SIGN CRITERIA

BASELINE PROFESSIONAL PLAZA

DR96-44 Approval of a sign packet for wall signs for an office complex at 2451 East Baseline Road/Baseline Professional Complex. Applicant: Christy Signs

SIGN # 1

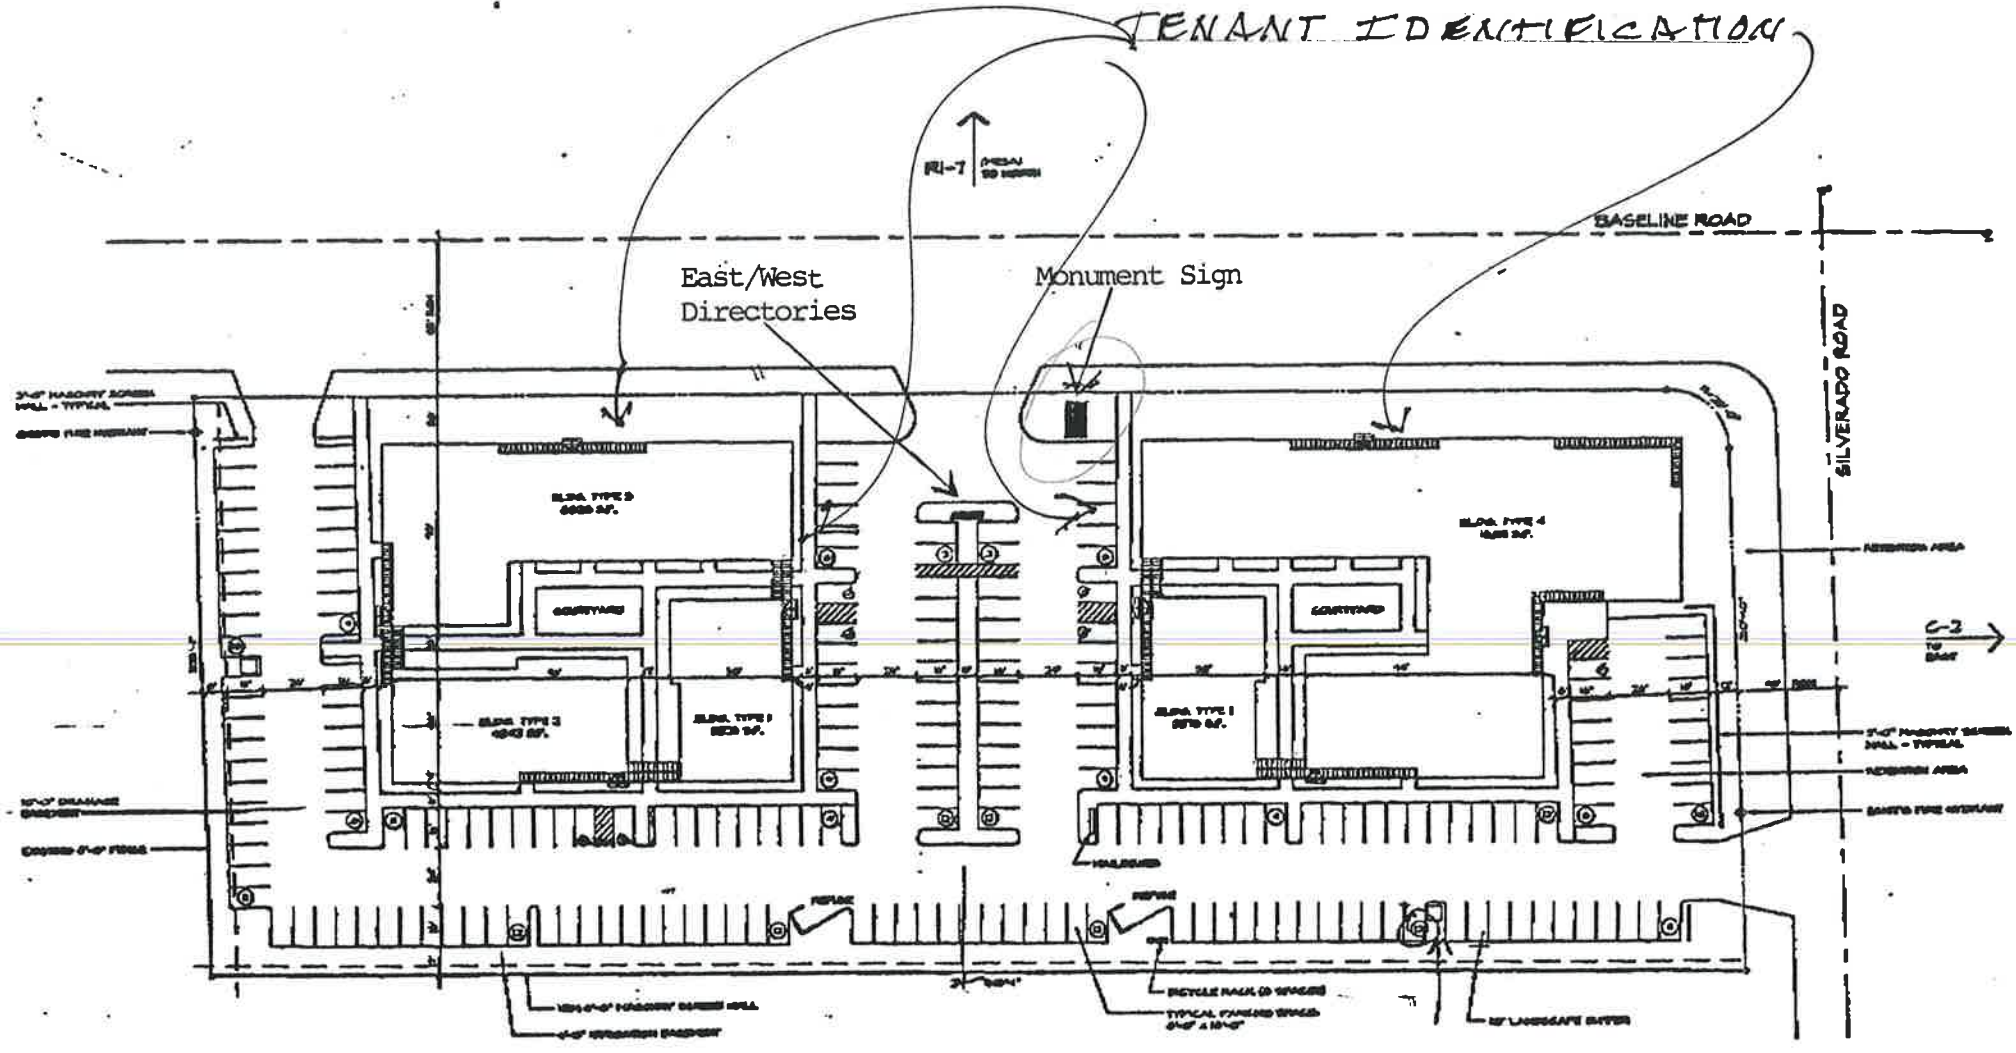
Mr. Christianson stated the passing public should be entitled to see an illuminated sign to advertise the 24 hour clinic. Chairman Truitt stated an illuminated sign would be one thing but different than internally illuminated. Chairman Truitt did not feel that the red of the sign was compatible with the building. It was discussed that the background of the sign was opaque and could be easily changed colorwise where it would be much more difficult to change the color of the letters. Mr. Christianson suggested picking up a color from the building and using the tile colors to tie the sign in with the building. Chairman Truitt was surprised that an urgent care facility was allowed in an office zoning but Planner Cadavid stated the zoning was actually commercial just the building was identified as a professional office complex. Chairman Truitt stated that changed his thinking since commercial zoning should be allowed to have internally lit signs, just as a Circle K would have. Board Member Hitzel recommended they go with a background lit sign for building 2 along Baseline Road but no internally lit signs to the residential areas. The existing sign would be internally lit and red in color and the monument sign would be internally lit as well. Mr. Christianson stated that any suites with courtyard entrances would only have directory signs applied to the wall. Mr. Christianson pointed out another sign that was internally lit at the same location and he recommended the same availability of color as that one. Chairman Truitt stated that every other commercial site is allowed three or four gaudy colors and internally lit and he felt they were being more picky since this was named a professional office complex instead.

3. The background color of the monument sign shall be compatible with one of the five colors except the lightest color.
4. Base planter shall be completed per the original design approved by the Board in August 1994 (DR94-26).

(Baseline frontage) (WEST BLDG.) NORTH ELEVATION

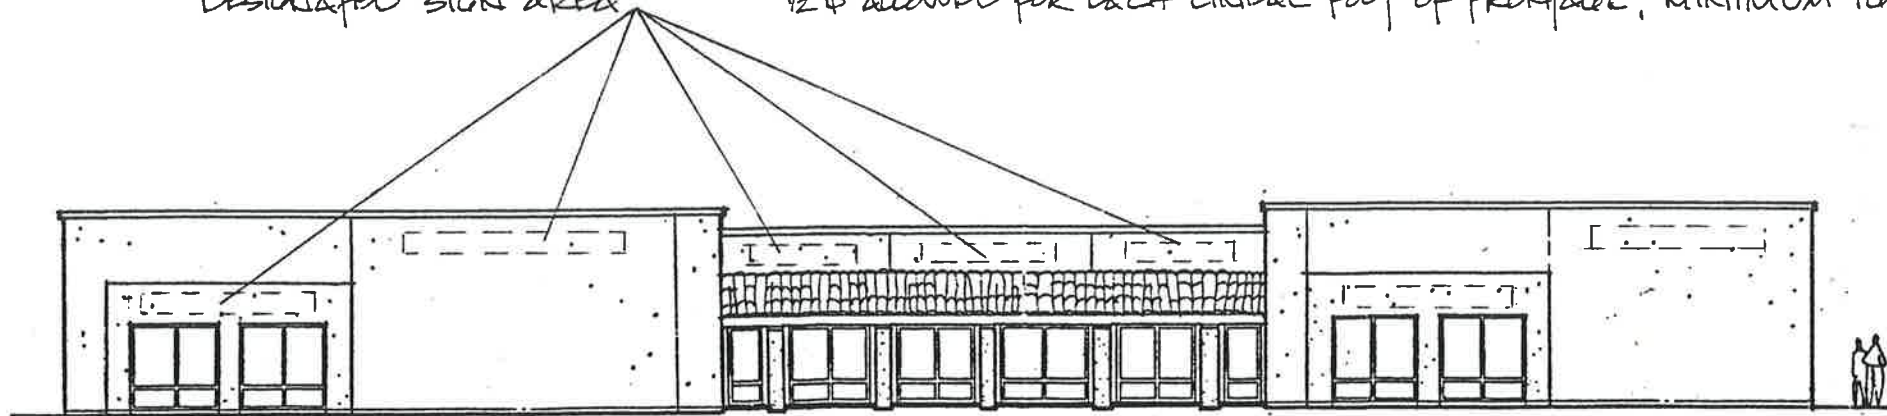
1. No internally illuminated signs will be allowed except along Baseline Road.
2. The sign turned off on the east elevation of the westerly most building (Urgent Care Facility) will remain turned off.
